Access Compliance Report Public Rights-of-Way (Curb Ramps)

Main Street: ETHEREAL_RD		Cross Street: N/A		Location:	SW
ADA ID: RPRK211103164141	Ramp Type: Type 4 - Parallel	Initial Pass/Fail: Fail	Overall Compliance: No	Severity Score:	2
Codes/Mitigation Info/Possible Solution			Field Measurements/Component Compliance

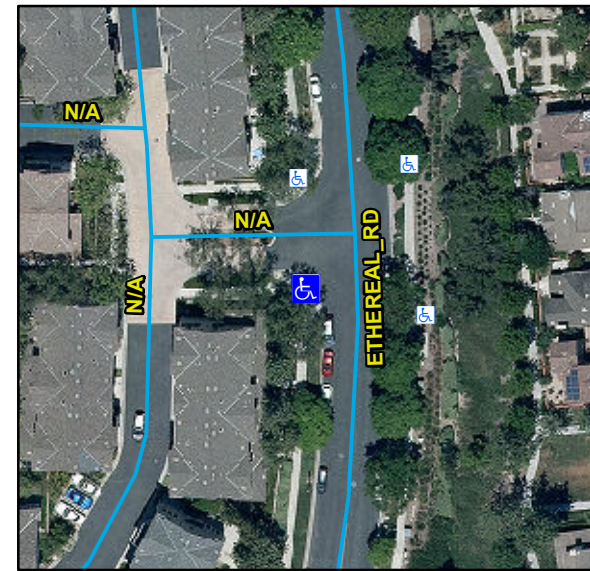
R304.5.3, STD 1115

Remove & Replace Curb Ramp With Two New Directional Ramps or Equivalent.
